TECHNICAL SERVICE BULLETIN**No.19-2378**
12 December 2019

This bulletin supersedes 18-2383. Only refer to the electronic version of this TSB.

Subject/Concern:	Buzz noise from the engine compartment audible in the interior mainly from the front left foot area during driving, when the engine is hot (> 90°C) and engine speed between 1600-2000 rpm especially at warm ambient conditions
Model:	
Fiesta 2017.0 (01/2017-)	Build Date: 01.05.2017 – 11.11.2019 Build Code: HB – KM Assembly Plant: Niehl (Cologne) Engine: 1.0L EcoBoost (74kW/100PS) Engine: 1.0L EcoBoost (90kW/120PS) Engine: 1.5L EcoBoost (147kW/200PS) - I3 (YZ)
Fiesta 2017.0 (01/2017-)	Build Date: 01.05.2017 Onwards Build Code: HB Onwards Assembly Plant: Niehl (Cologne) Engine: 1.0L EcoBoost (70kW/95PS) Transmission/Transaxle: - 6-Speed Automatic Transmission – 6F15
Fiesta 2017.0 (01/2017-)	Build Date: 01.05.2017 Onwards Build Code: HB Onwards Assembly Plant: Niehl (Cologne) Engine: 1.0L EcoBoost (103kW/140PS) (YY)

Install two O-ring seals on the **lower** spigot.

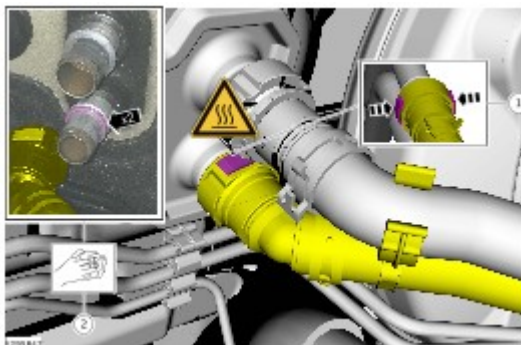
Should a customer express concern about buzz noise from the engine compartment audible in the interior mainly from the front left foot area during driving, when the engine is hot (> 90°C) and engine speed between 1600-2000 rpm especially at warm ambient conditions, the probable cause is excessive clearance between the heater hose quick connector to the heater core spigot.

To rectify this concern, two O-ring seals should be installed to the heater core lower spigot.

1. Disconnect the **lower** quick connector from the heater core spigot.
2. Clean the spigot from coolant residues and install the O-ring seals (see Parts Required).
3. Install the lower quick connector and ensure an rectangular installation position. Push slightly until you notice an audible click from the quick connector. Don't push the quick connector too far otherwise the O-ring seals will be pushed above the bead on the spigot.
